S&S WORLDWIDE <i>Engineering Excitement</i>	Issuing Entity: S&S Worldwide 350 West 2500 North Logan, UT 84341 United States P: +1-435-752-1987 F: +1-435-752-1948 www.engineeringexcitement.com	Bulletin No.: 200117
		Release Date: 1/22/2018
		Effective Date: 1/22/2018
		Supersedes:
		Completion Date:

Service Bulletin

Abstract Of Issue: Tower Restraint Upgrade

Option 2 - Remove single hydraulic restraint and replace with dual mechanical bumpy rod restraint.

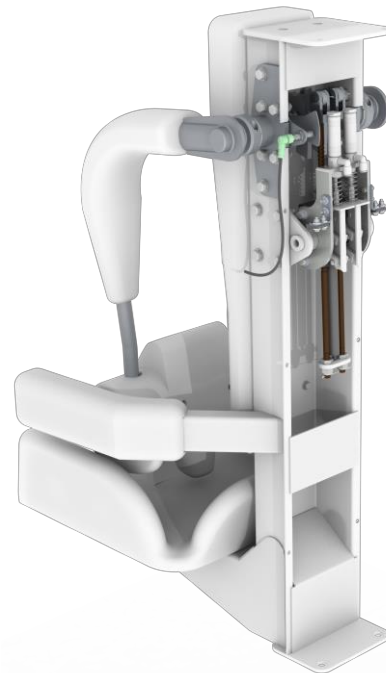
- Second restraint mechanism for redundancy.
- Proven mechanical bumpy rod system replaces hydraulic system.
- Ability to measure minimum closed position locking of restraint pawl.
- Rework tower components as lower cost option.
- Keeps floating ride experience for passengers.
